# UNITED STATES PATENT AND TRADEMARK OFFICE

APPLICATION NO.	FILING DATE	FIRST NAMED INVENTOR	ATTORNEY DOCKET NO.	CONFIRMATION NO.
10/042,057	01/07/2002	Manfred Baldauf	GR 99 P 8088	4485
24131	7590	05/20/2005	EXAMINER	
LERNER AND GREENBERG, PA P O BOX 2480 HOLLYWOOD, FL 33022-2480			WILLS, MONIQUE M	
			ART UNIT	PAPER NUMBER
			1746	
DATE MAILED: 05/20/2005

**Office Action Summary**

**DETAILED ACTION**

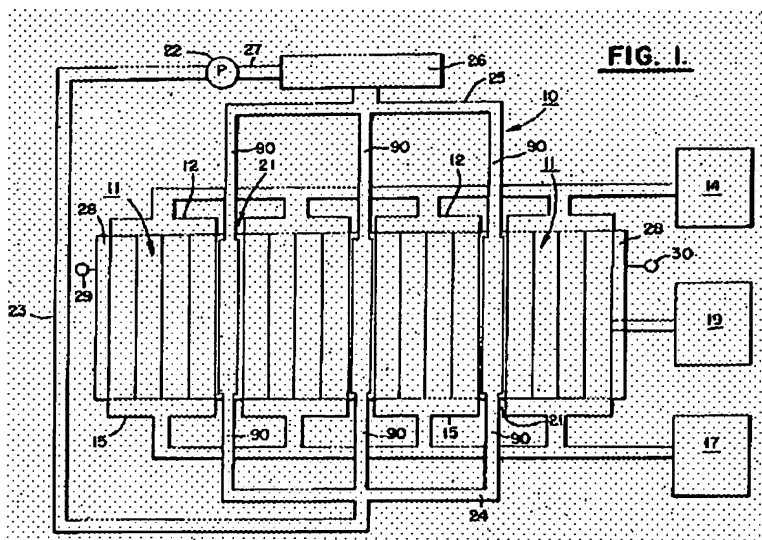
The reference is silent to at least two of the subsystems having respective cooling circuits, configured to be connected by series or parallel.

However, Wittel teaches that it is conventional to employ subsystems having respective cooling circuits in series/parallel as illustrated in Figure

in order to maximize heat transfer from the fuel cell stack to the coolant without undue manufacturing and assembly tolerances and to avoid shunt currents without the need for additional electrical isolation form adjacent cells of the fuel cell stack. See column 3, lines 5-25.

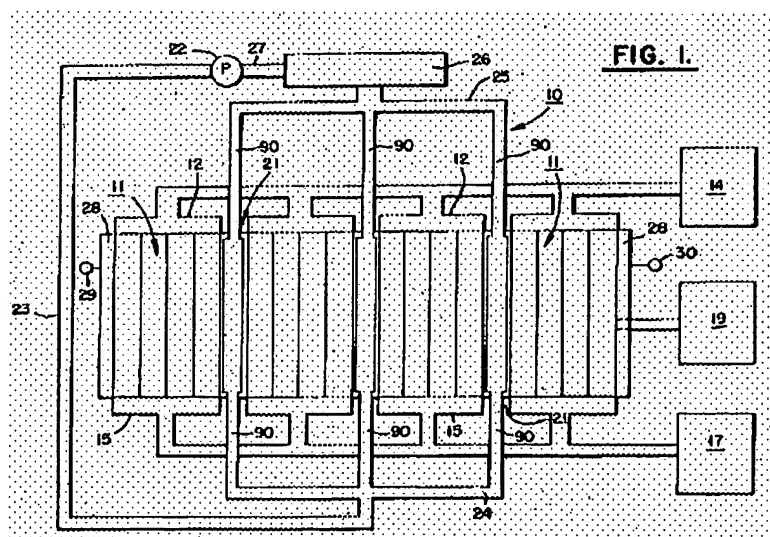
The reference is silent to at least two of the subsystems having respective cooling circuits, configured to be connected by series or parallel.

However, Wittel teaches that it is conventional to employ subsystems having respective cooling circuits in series/parallel illustrated as in Figure 1:

in order to maximize heat transfer from the fuel cell stack to the coolant without undue manufacturing and assembly tolerances and to avoid shunt currents without the need for additional electrical isolation from adjacent cells of the fuel cell stack. See column 3, lines 5-25.
